Anglia have been advised by the supplier ELECTRONIC SENSOR INC that the current case style for part number SRHR-233C will no-longer be supplied due to tooling that has worn between its serviceable life.

The new case style can be seen below (left image)

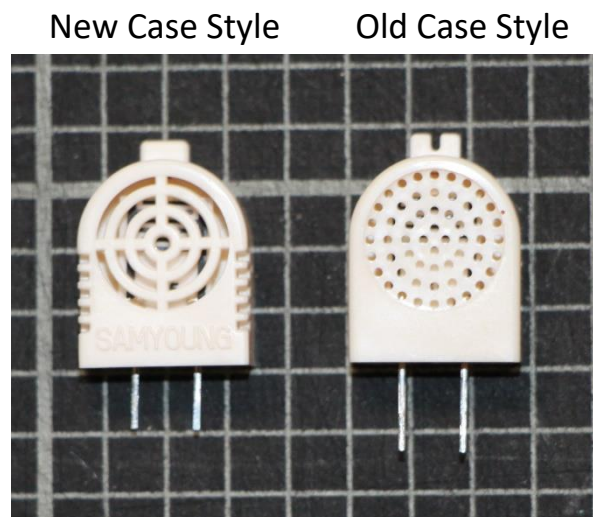
The function of the device remains the same however along with the cosmetic case change the lead length has been reduced from 7mm to 5mm.
